**SECTION 4.55(1A) MODIFICATION APPLICATION TO SSD 16_7919 - RESPONSE TO RFI 2
85 CARABELLA STREET, KIRIRIBILLI**

This response to request for additional information is provided to address your letter dated 12 August 2019. A response to each of the Department's queries is outlined below. A response is also provided to the public submission received from the owners of 22 Elamang Avenue, Kirribilli.

Figure 1 – DA 2201 (Lower Ground 4 Plan) explanatory diagram

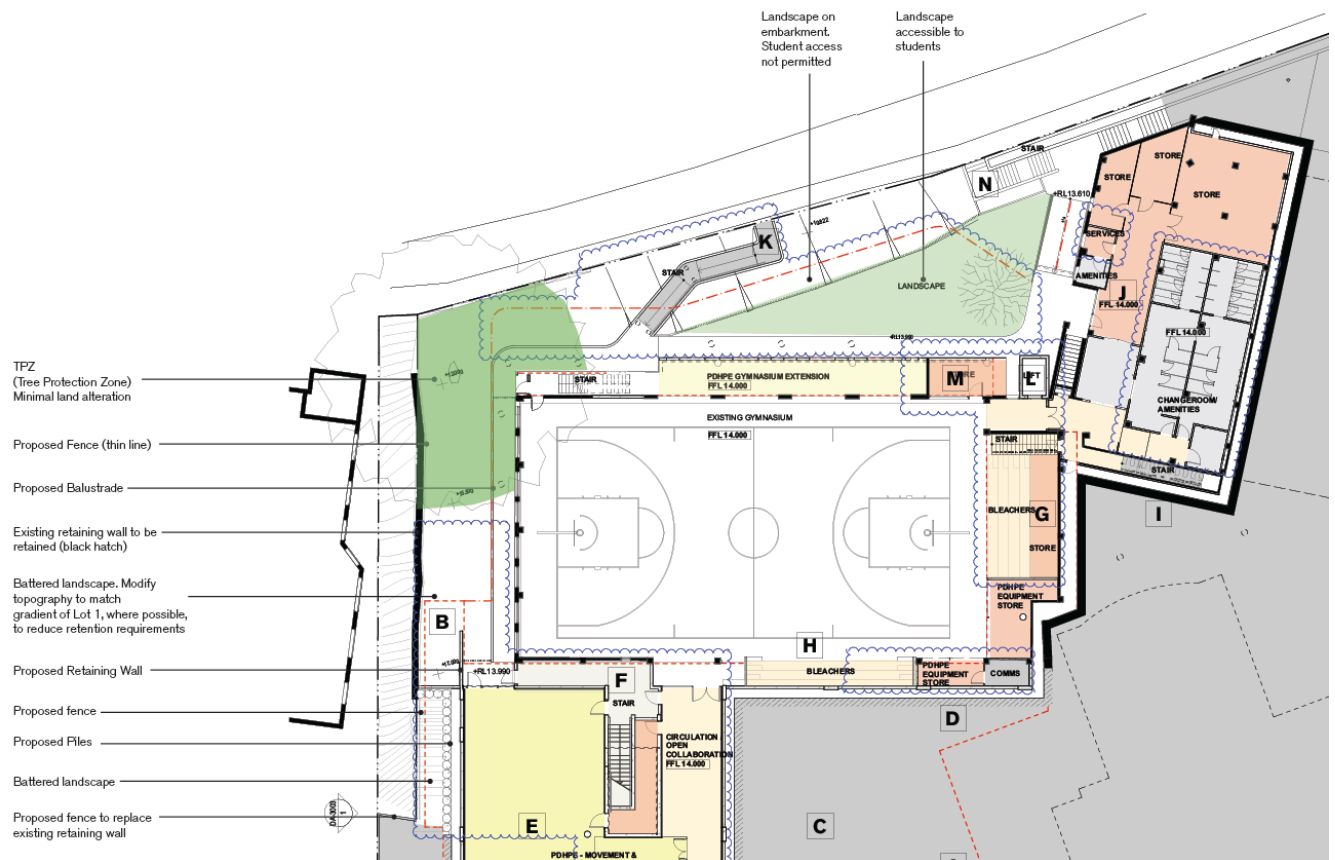
1. The submitted plan DA-2201 Rev 03 includes the following:

- *circular features that appear to be columns, on the western boundary.*
- *an excavated area adjoining the columns on the boundary.*
- *windows on the western elevation of the gymnasium.*

These elements / features are not reflected on the Western Elevation (drawing no. DA-3303 Rev 1). Please clarify what these features are (including any retaining walls in the excavated area) and amend the elevation to include the additional elements including the windows, if any.

The circular features shown on DA-2201 Rev 03 are structural piles required to retain soil from the adjoining vacant land referred to as Lot 1 in DP 115513. The piles are underground, so they cannot be seen on the Western Elevation. The area to the west of the piles is existing soil battered down from the boundary towards the east. Only the top of the batter can be seen on the Western Elevation.

Figure 2 – DA 3003 (Western Elevation) explanatory diagram

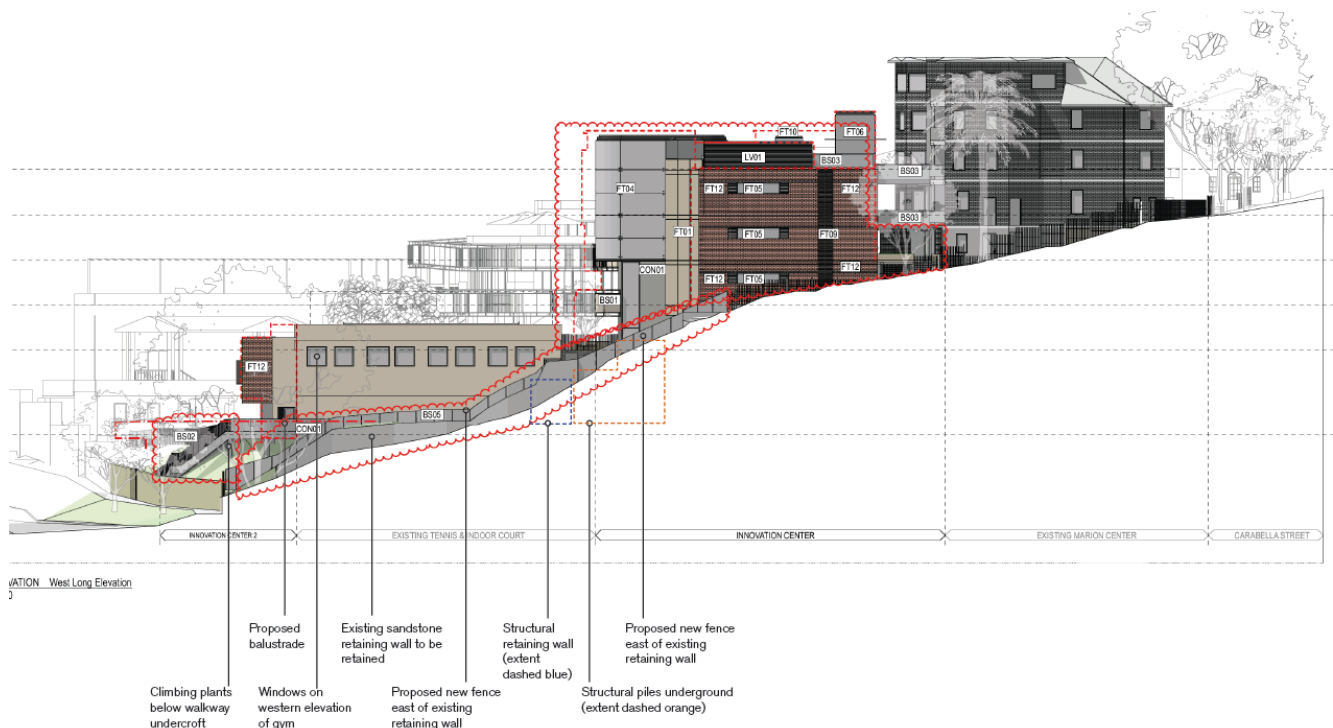
2. *An emergency walkway is proposed along the western elevation of the gymnasium, which would extend to the landscaped deck at the Elamang Avenue frontage. Please confirm whether a balustrade is proposed along the western edge of this walkway. Currently, the plans do not indicate a balustrade, however it is shown on the western elevation (DA-3303 Rev 03).*

Currently we have not submitted a drawing numbered DA-3303. It is assumed that the Department is referring to DA-3003.

High level windows on the gymnasium are shown on the submitted Western Elevation (DA-3003 Rev 1). Please refer to DA-3003 (attached) and the explanatory diagrams at **Figures 1 and 2**.

The majority of the retaining wall will remain. This is shown on the annotated elevations at **Figures 2 and 3** above. It is noted that appearance of the wall on the Western Elevation has changed as a result of modifications to the landform, which has now been revised following more detailed surveys. There have not been any changes to the wall itself.

Figure 3 – DA 3002 (Northern Elevation) explanatory diagram

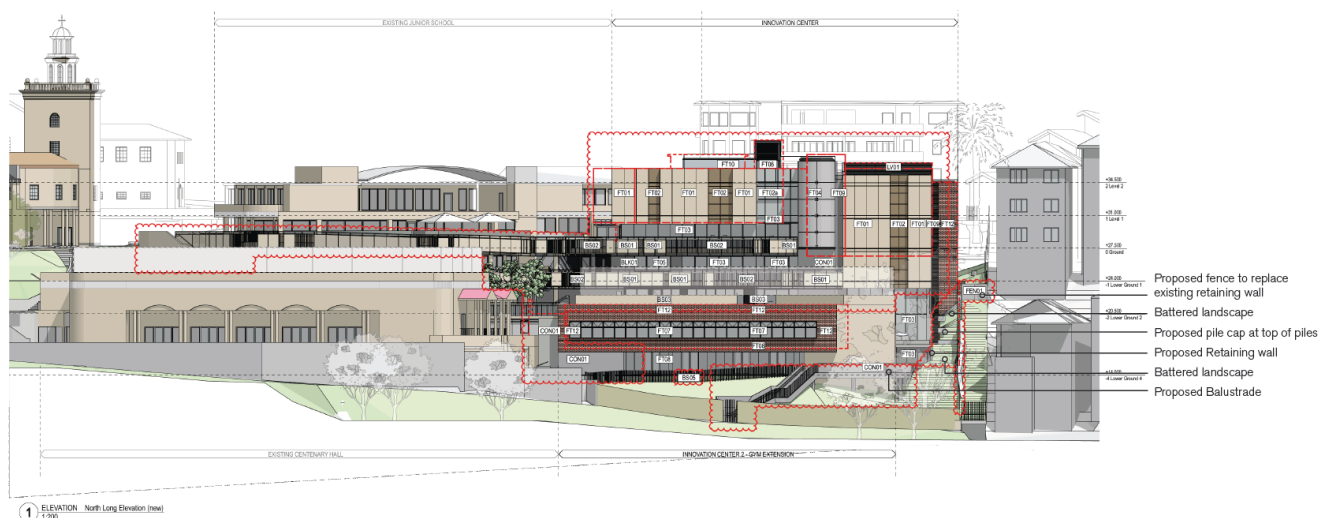
3. *As previously requested by the Department, the landscape plans are required to include all Relative Levels (RLs). The Department notes that the landscape plans for Stage 1 generally include levels except the western section (adjoining the gymnasium) where an embankment is proposed. Please provide the RLs to confirm the top and bottom of the landscaped embankment between the walkway and the site boundary. In the case where an embankment is not proposed at this location, please confirm whether the walkway is proposed to be supported on columns (currently not shown on plan or elevation).*

Columns are proposed under the suspended walkway. Refer to amended drawings DA-2201 and DA-3003 (attached) and the explanatory diagram at **Figure 3**.
